1. INTRODUCTION

This document is a response to a request for further information ('Requested Information') regarding a number of issues from the Environmental Protection Agency (EPA) in relation to the IE application Ref: W0242-02 for a materials processing and transfer facility at the Millennium Business Park, Cappagh Road, Dublin 11, made by Thorntons Recycling.

This request was contained in correspondence from the EPA, dated 15th May 2017.

Figure Title	Path of Proposed Storm Water Discharge to Tolka River	
Figure No.	2.1	
Project	Millennium Park IE RFI	
Client	Thorntons Recycling	
Scale	1:20,000	Page Size A3
Revision	A	Date 05/07/2017

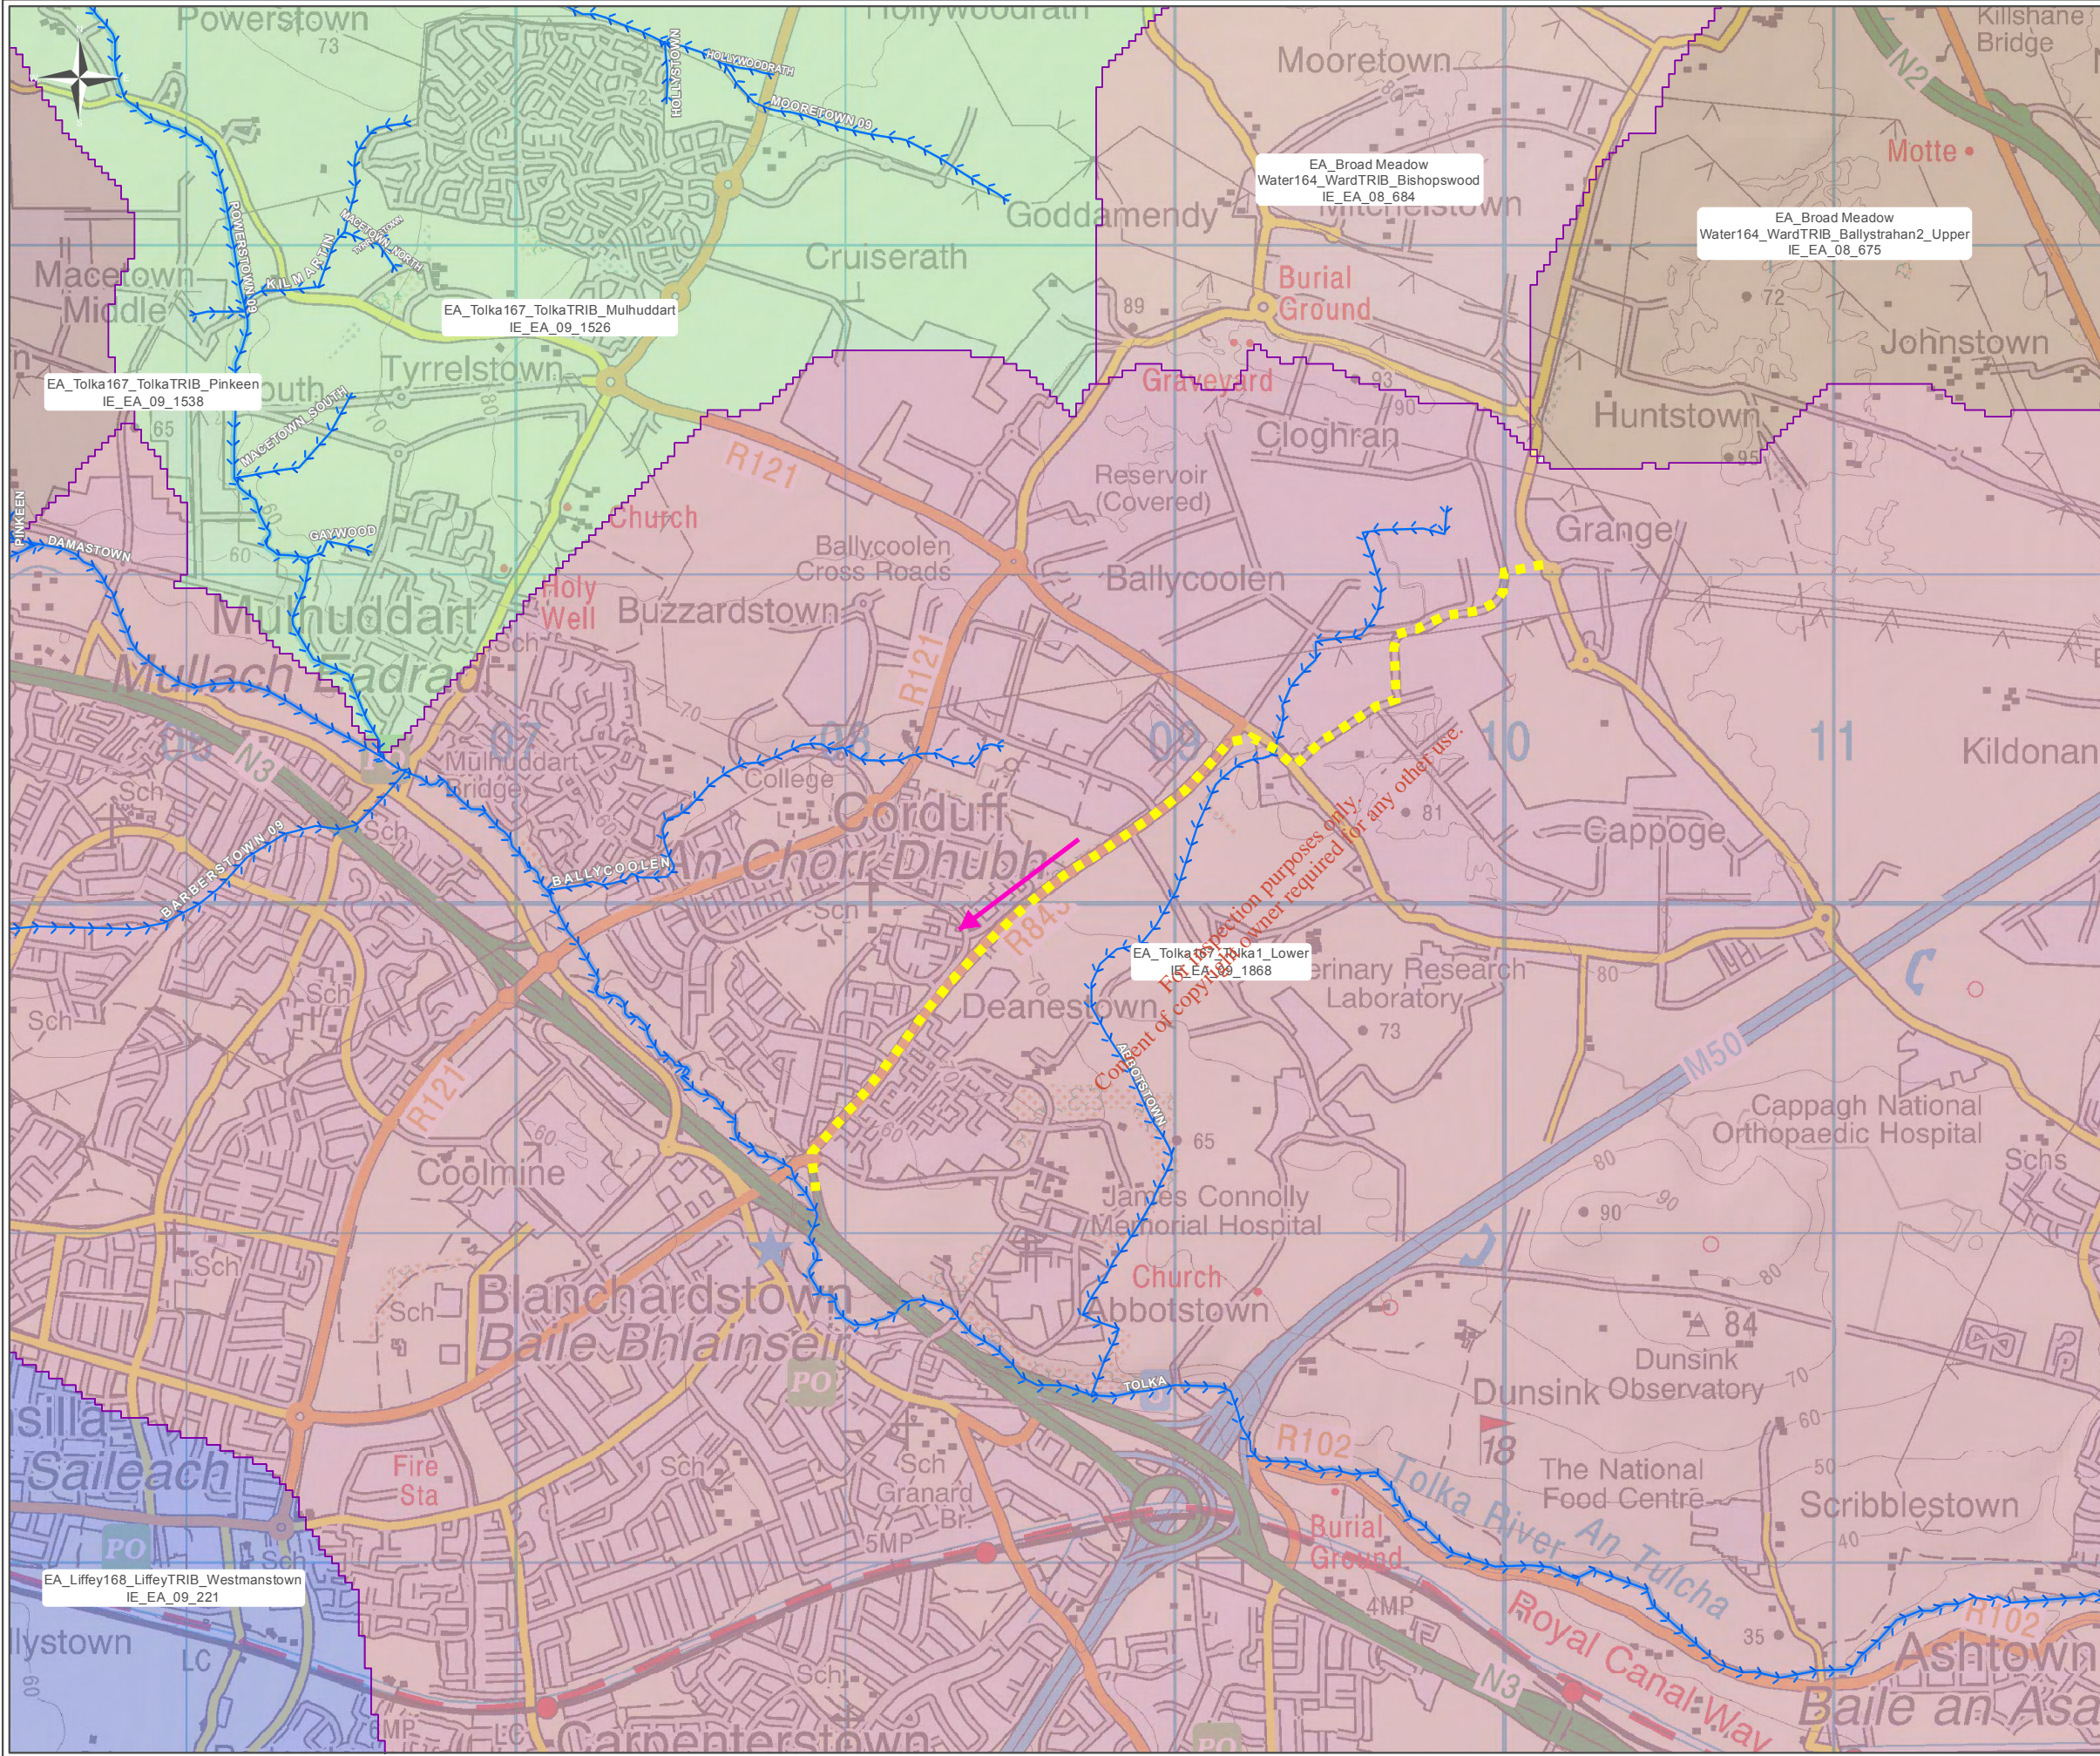
- EPA (2016) Guidance on Fire Risk Assessment for Non-Hazardous Waste Facilities
- EPA (2013) Guidance Note – Fire Safety at Non-Hazardous Waste Transfer Stations
- EPA (1995) Draft Guidance Note to Industry on the Requirements for Fire-Water Retention Facilities
- UK Environment Agency (2013) Reducing fire risk at sites storing combustible materials: Technical Guidance Note 7.01
- *Indicate on a drawing the linkage and path between the proposed storm water discharge point SW1, Bachelors Stream and the Tolka River.*

From Figure 2.1 please note the linkages and pathway between the proposed storm water discharge point SW1 to the Tolka River. The storm water from the entire Millennium Business Park, to which the proposed development adjoins at SW1, flows in a piped system to the discharge point directly into the Tolka River. The information that facilitates the development of Figure 1-1 has been provided by the operators of the Millennium Business Park.
